Change of lot number format in bar code labelling and marking of physical units affecting products assembled at GTBF, Ltd., China

N° 003/20

Subject: Change of lot number format in bar code labelling and marking of physical units affecting products assembled at GTBF, Ltd., China

Change of Lot Number Format on Marking and Barcode Label

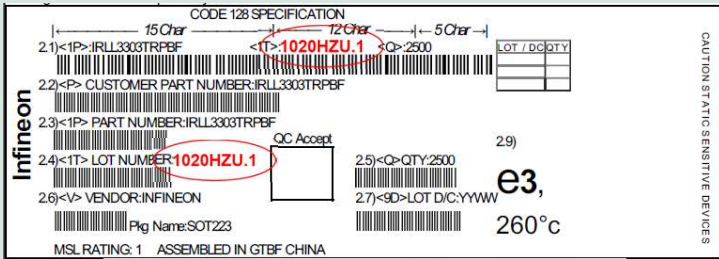
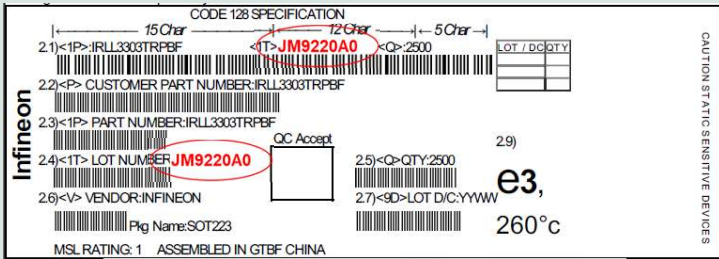
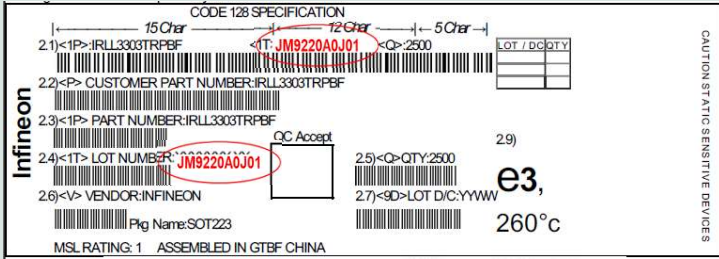
Item	Current	To-Be
Lot Naming Format	<u>XXXXXXXX</u>.<u>N</u> First 3 characters-numeric Next 4-7 characters-alphanumeric N = Lot Split	KKJWWAAASXX KK = Lot Pattern (JM for GTBF) J = Last Digit Calendar Y (0 – 9) WW = Log Week (Lot Creation) based on Infineon calendar (Oct to Sep) AAA = Alpha numeric lot numbering (000 – ZZZ) S = Split Code (J for GTBF) XX = alpha numeric counter for split code (01-ZZ)
Lot Number	1020HZU.1	JM9220A0J01
Marking of Physical Units	Material: IRL3303TRPBF Package: SOT223 ABCD -> 0HZU	Material: IRL3303TRPBF Package: SOT223 20A0
